# Access Compliance Report

## Public Rights-of-Way

Intersection ID: 44268	Main Street: ISAAC_HUNTER_DR	Cross Street: EMILY_HOPE_DR	Location: E
ADA ID: 853A7615E4E5	Ramp Type: PerpDiag	Initial Pass/Fail: Fail	Overall Compliance: No
Codes/Mitigation Info/Possible Solution		Field Measurements/Component Compliance	
Severity Score: 8.75

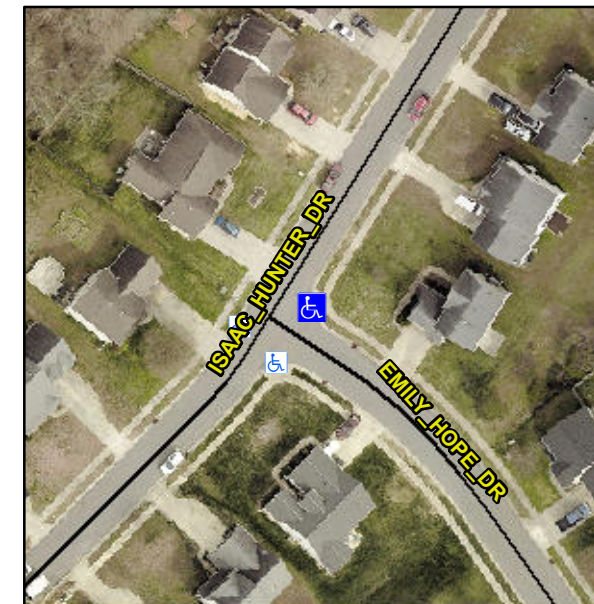
**Not Found, R304.5.1**

Compliance	Description	Data	Compliance	Description	Data
N/A	Ramp Length (in)	48.5	Yes	Ramp Slope (%)	7.6
No	Ramp Width (in)	46.0	Yes	Ramp XSlope (%)	0.1
N/A	Flare Type LT	N/A	N/A	Flare Type RT	N/A
N/A	Flare Slope LT (%)	N/A	N/A	Flare Slope RT (%)	N/A
N/A	Flare Traversable LT?	N/A	N/A	Flare Traversable RT?	N/A
N/A	Landing Length (in)	N/A	N/A	DWS Provided?	N/A
N/A	Landing Width (in)	N/A	N/A	DWS Contrast?	N/A
N/A	Landing Slope (%)	N/A	N/A	DWS Length (in)	N/A
N/A	Landing X Slope (%)	N/A	N/A	DWS Full Width?	N/A
N/A	Landing Curb? (Y/N)	N/A	N/A	DWS Offset (in)	N/A
N/A	Shared Landing?	N/A			
N/A	Gutter Ponding?	N/A	N/A	Gutter Slope (%)	N/A
N/A	Gutter Lip Ht (in)	N/A	N/A	Gutter X Slope (%)	N/A
N/A	Painted X Walk1?	No	N/A	Painted X Walk2?	No
	X Walk 1 Direction	To NW		X Walk 2 Direction	To SW
N/A	X Walk 1 Width (in)	N/A	N/A	X Walk 2 Width (in)	N/A
	X Walk 1 Slope (%)	2.2		X Walk 2 Slope (%)	0.5
	X Walk 1 X Slope (%)	0.3		X Walk 2 X Slope (%)	1.0

**Remove & Replace Curb Ramp With Two New Directional Ramps or Equivalent.**
